SUBJECT: NRC SPECIAL INSPECTION REPORT - INDIAN POINT UNIT 2
STEAM GENERATOR TUBE FAILURE - REPORT NO. 05000247/2000-010

Report No. 05000247/2000-010

Facility: Indian Point 2 Nuclear Power Plant

Figure 5 - Crack in tube 2-67 of steam generator 24, found in 1997.

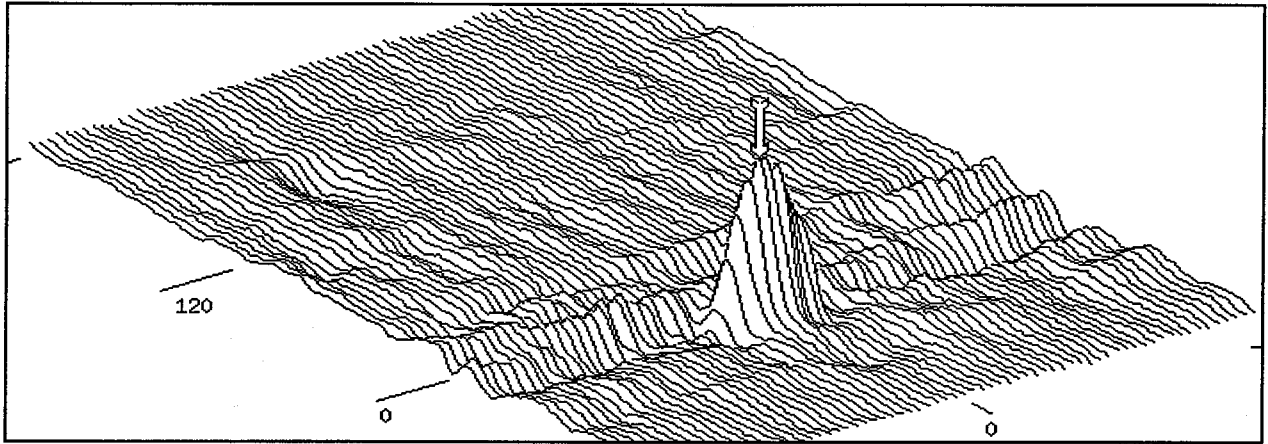
The c-scan plot of the 1997 data from R2C67 is shown in Figure 5. The crack sits beside a noise ridge, in a valley, and is in an easily detectable portion of the tube. The large amplitude of the voltage signal, in relation to the standard calibration notch, would indicate that this is a "mature" crack. No year 2000 data is available since the tube was plugged in 1997.

While the flaw was identified and the tube plugged, neither Con Edison nor its ECT contractor identified the discovery of the low-row U-bend apex indication as a significant condition adverse to quality. There was no specific review as to the significance of this flaw or the possible extent of the condition. Identification of this flaw was significant, because it was the first observation of this type of degradation at the apex of a low-row U-bend SG tube at Indian Point 2. Further, apex cracks, if not detected and removed from service, have a greater likelihood of causing a tube rupture than other U-bend cracks, based on past industry events including the Surry 1 tube rupture in 1976 and the Doel (Belgium) tube rupture in 1979. This issue was not entered into the corrective action program.

Figure 6 R2C5C-scan with 1997 phase setting.

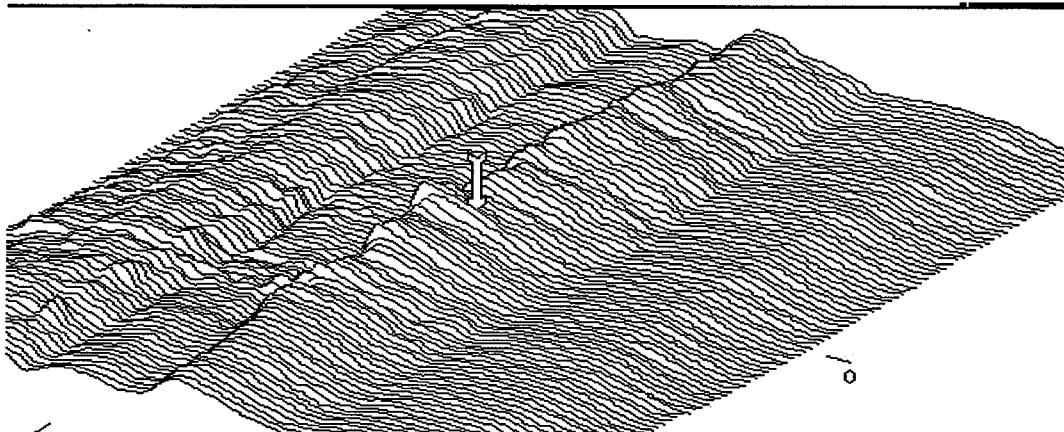
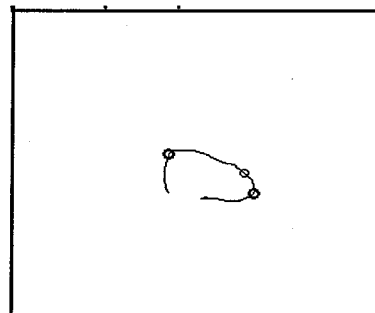
1. R2C5 in SG 24 - Figure 6 is a c-scan plot of the vertical component of the ECT voltage signal. The defect signal, indicated by the arrow, sits on a noise ridge that runs the length of the tube. This noise ridge is about 1-volt in amplitude. This ridge makes both the detection and sizing of this defect difficult, because of the very low signal-to-noise ratio. Figures 7 and 8 are the lissajous plots for the flaw area and the noise ridge, respectively. No year 2000 data is available since the tube failed.

Figure 9 - 1997 mid-range scan

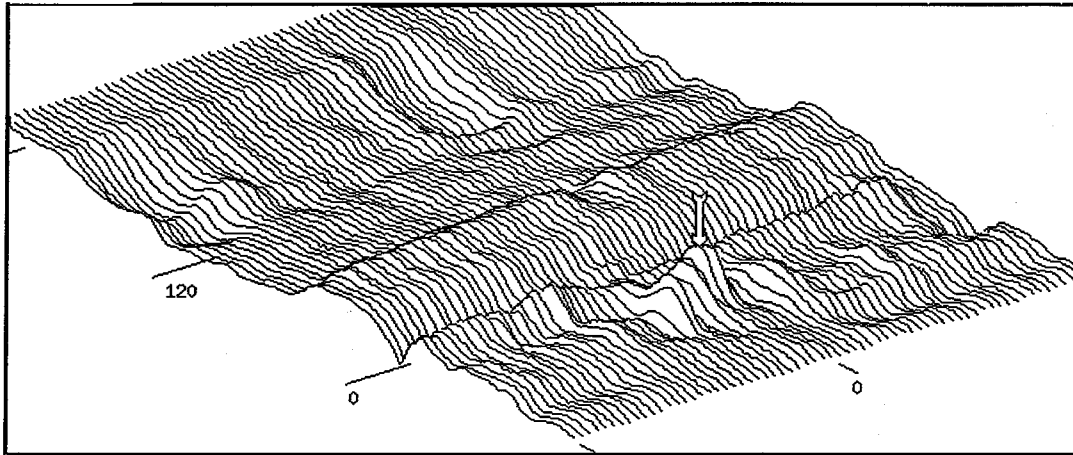
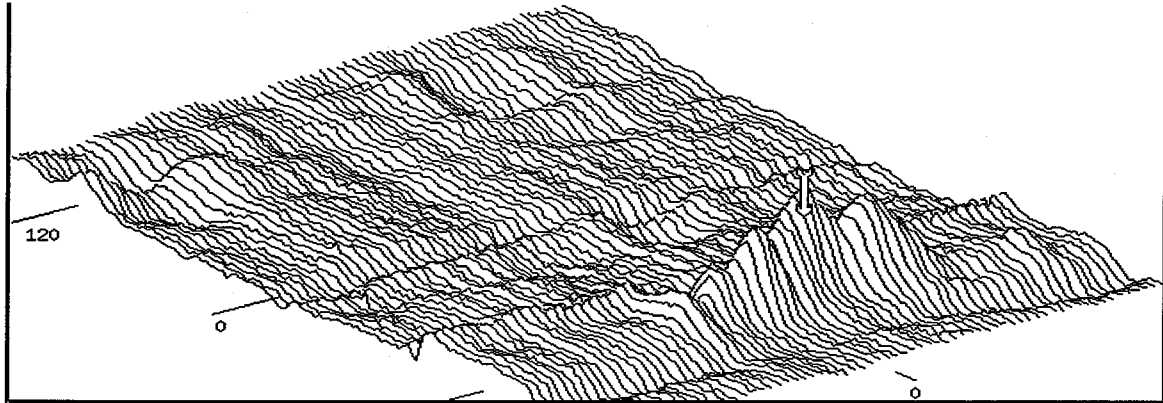
2. R2C69 in SG 24 - Figure 9 shows the c-scan plot for the 1997 data. There is considerable noise present. For comparison, the c-scan plot for the 2000 data is included as Figure 10. The noise features between the 1997 and 2000 data are similar enough to verify that this is the same defect at the same location. The defect voltage is only about 1 volt, and there is a considerable amount of noise on the tube relative to the defect signal, i.e., low signal-to-noise ratio.

Figure 11 - 1997 scan

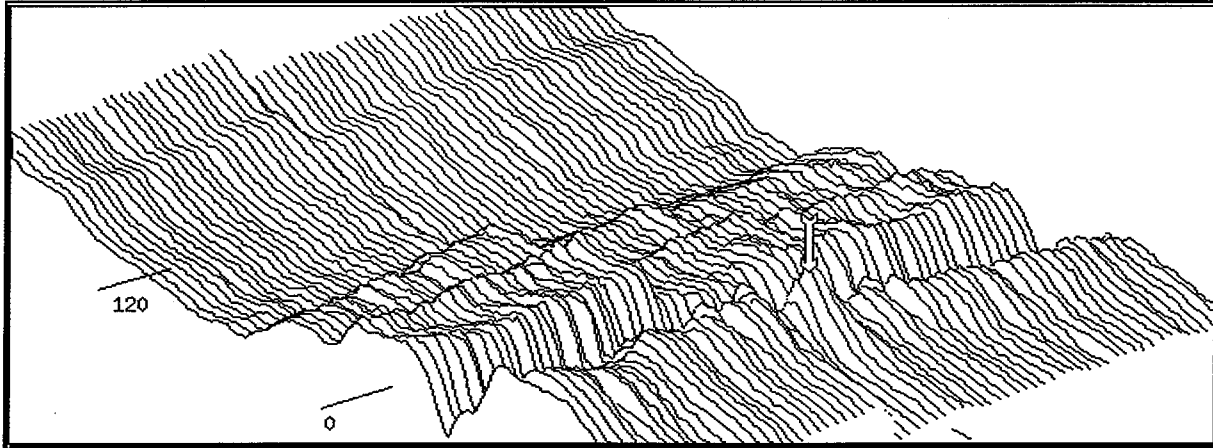
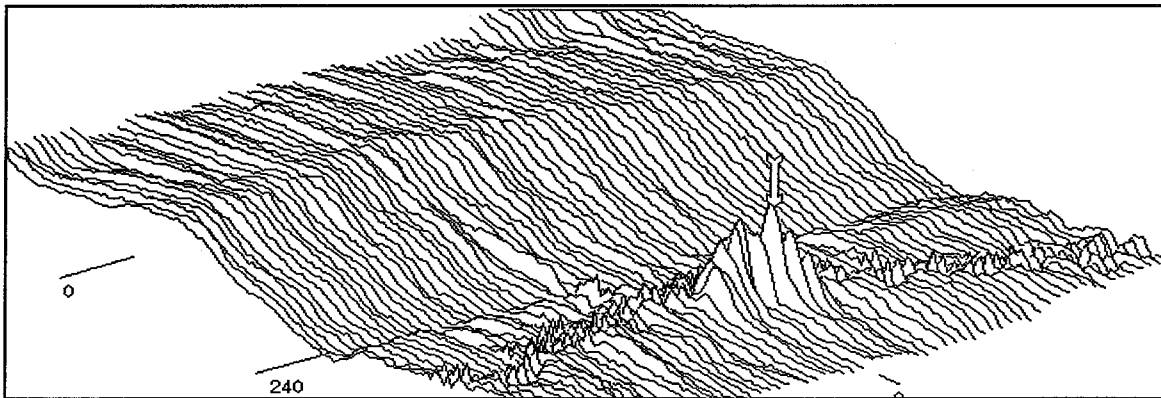
3. R2C72 in SG 24 - Figure 11 shows the c-scan plot of the 1997 data. There is considerable noise present. The crack is sitting in a ridge of noise and barely extends above the ridge. For comparison, the c-scan plot for the 2000 data is included as Figure 12. The crack barely extends above a 1-volt amplitude for a short length and exhibits a low signal-to-noise ratio.
4. R2C87 in SG 21 - this tube was identified as having several cracks. Figure 13 shows the c-scan plot of the 1997 data. The most prominent crack is sitting in a relatively clean area of the tube. For comparison, the c-scan plot for the 2000 data is included as Figure 14.
